Austin Woods Drive

All Public Input

Multiple Choice Response Summary

Open-Ended Responses

Q2 How comfortable are you with Option 1?

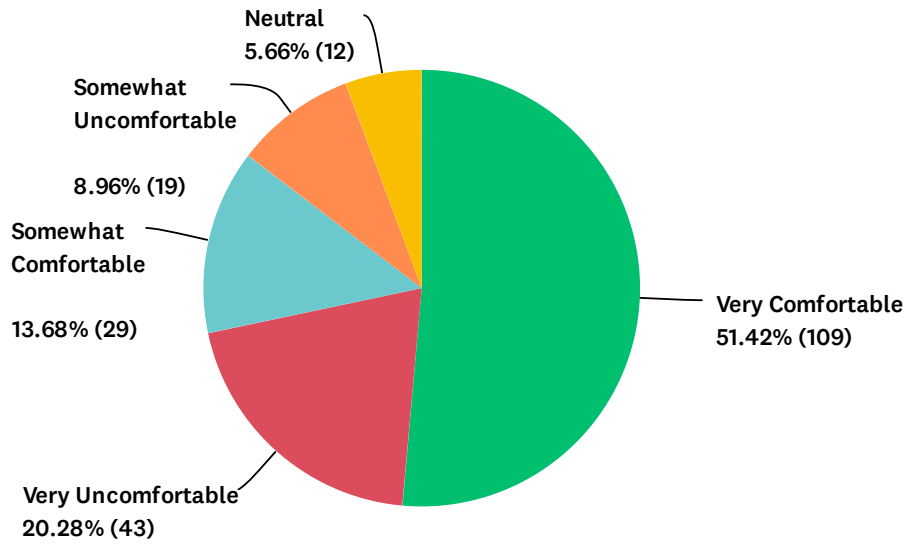
ANSWER CHOICES	RESPONSES	
Very Comfortable	51.42%	109
Very Uncomfortable	20.28%	43
Somewhat Comfortable	13.68%	29
Somewhat Uncomfortable	8.96%	19
Neutral	5.66%	12
TOTAL		212

Q3 How comfortable are you with Option 2?

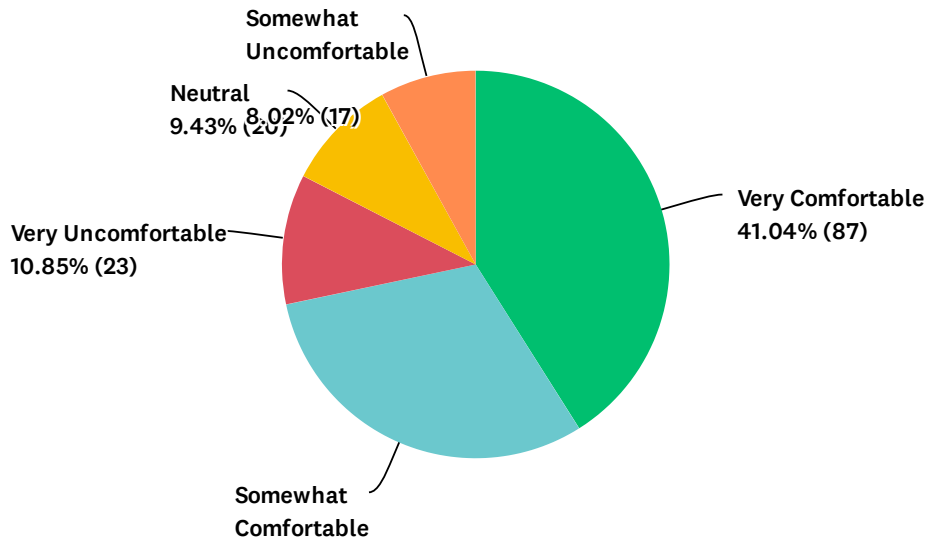
ANSWER CHOICES	RESPONSES	
Very Comfortable	41.04%	87
Somewhat Comfortable	30.66%	65
Very Uncomfortable	10.85%	23
Neutral	9.43%	20
Somewhat Uncomfortable	8.02%	17
TOTAL		212

Q4 How comfortable are you with Option 3?

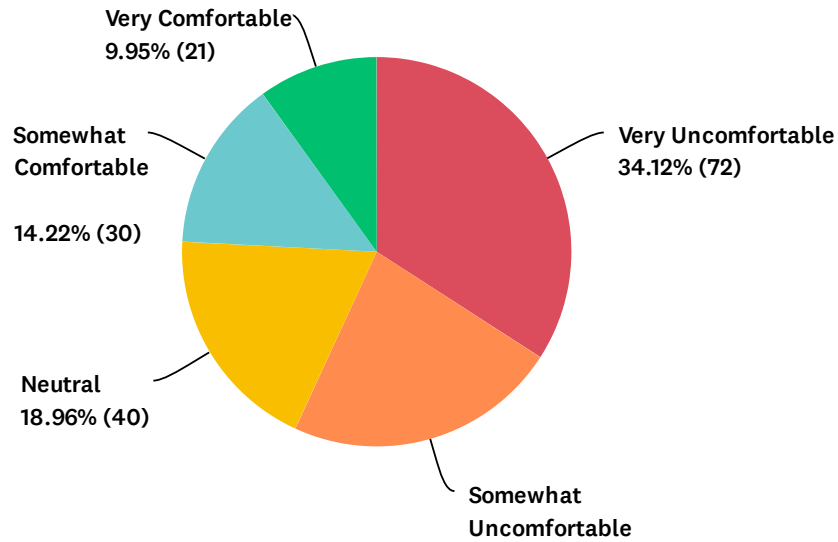
ANSWER CHOICES	RESPONSES	
Very Uncomfortable	34.12%	72
Somewhat Uncomfortable	22.75%	48
Neutral	18.96%	40
Somewhat Comfortable	14.22%	30
Very Comfortable	9.95%	21
TOTAL		211

Q5 How comfortable are you with Option 4?

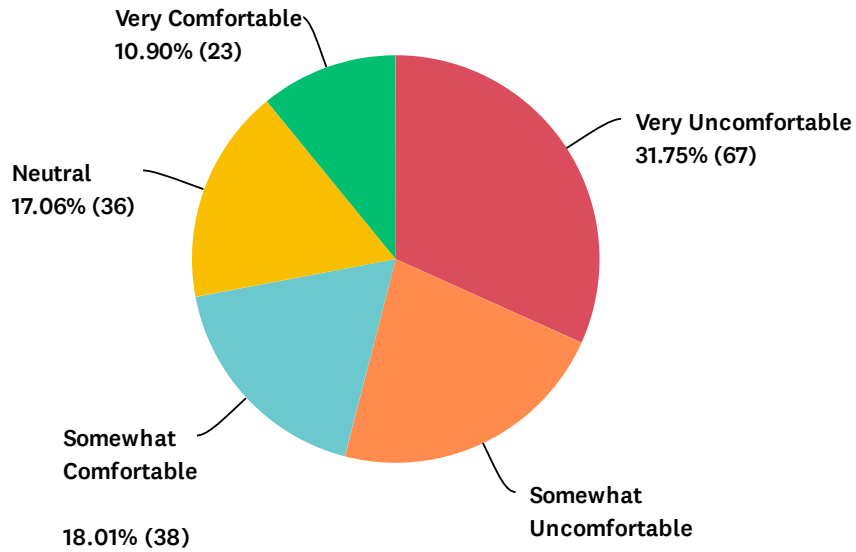
ANSWER CHOICES	RESPONSES	
Very Uncomfortable	31.75%	67
Somewhat Uncomfortable	22.27%	47
Somewhat Comfortable	18.01%	38
Neutral	17.06%	36
Very Comfortable	10.90%	23
TOTAL		211
